## INFORMATION BULLETIN NO. 111

**SUBJECT: CYLINDER RETAINER PIN ON DRILL CANOPY**

SHEET NO. MY-2300	TITLE 413278 SUPPORT POST RETAINING PIN ASSEMBLY	DATE 11/02/06	 <a href="http://www.lhfletcher.com">www.lhfletcher.com</a>
----------------------	---	------------------	---

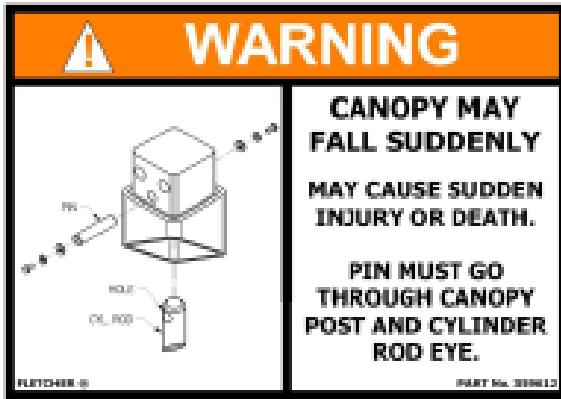
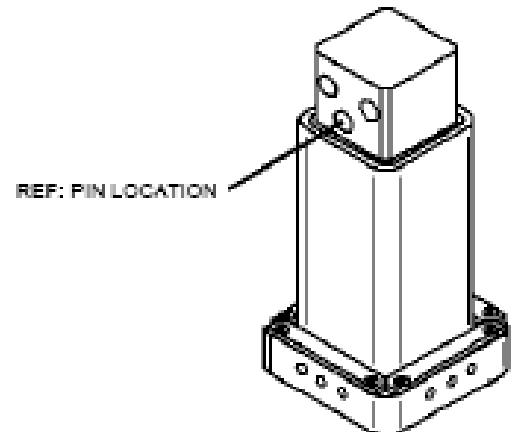
2. If you are the owner of a Fletcher machine with the design described in IB 94 that shows the round pin going through the cylinder, Fletcher has an additional update for your bolter (see Machine List in Attachment 1). The pin that goes through the cylinder rod has been modified to reduce any chance that the pin may dislodge and fall out. It is extremely important that the round pin goes through the hole in the cylinder rod. The new round pin has rubber washers on both ends. After the round pin is placed into the hole, the maintenance person must tighten down the bolts on both ends. The tightening of both screws on each end of the pin spreads out the rubber washer in the support post hole. This new design secures the connection and provides a rubber barrier that prevents contamination by dirt or other substances. These round pins can be ordered through Fletcher's Service Department (PN: 413278). Make sure that your parts department and maintenance personnel are aware of the change. Included in this bulletin is a drawing showing the correct part number of the round pin (see Attachment 2). Place a copy of the drawing in the parts book for your machine, and distribute copies to the appropriate personnel. Note: the new pin will be automatically substituted when ordering the previous pin design. Educate your maintenance personnel that anytime the canopy is removed, before reattaching it they must confirm that the cross pin that connects the cylinder rod to the support post is secured in and through the cylinder eye.

3. After the existing pin has been removed and replaced with the new pin, please **DESTROY** the old pin so that it cannot be used again. The warning tag (see Attachment 2) is part of the pin assembly and will be attached to the pin.
